# Technical Service Bulletin

## 01 MIL on, DTC P243600 and/or P243700 stored in ECM

01 19 97 2049142/4 January 2, 2019. Supersedes Technical Service Bulletin Group 01 number 18-65 dated April 19, 2018 for reasons listed below.

Figure 1. Replace the sender.

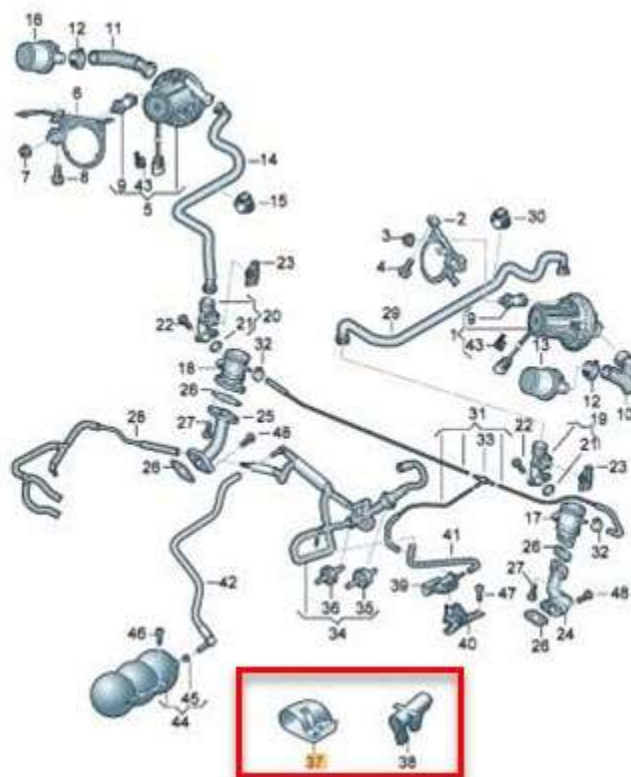
| REVISION HISTORY |            |  |
|------------------|------------|--|
| 4                | -          | Revised <i>Service</i> (Updated Step 2 and Figure 1)<br>Revised <i>Warranty</i> (Updated Labor Operations) |

1. Replace the Differential pressure sensor Bank 2 (G610) according to the Repair Manual, *Engine >> 24 Multipoint fuel injection >> air filter housing, removing and installing >> 26 Exhaust System>Secondary Air System >> Combination valve, removing and installing >> Secondary air injection sensor G609/G610, removing and installing.*
2. Then add the insulation (Figure 1, number 37 and 38) on the pressure sensor Bank 2.  
At the end of the repair the pressure sensor and the combination valve should have the insulation on both banks (Figure 1, number 37 and 38). See Figure 2 for an example of installed insulation.
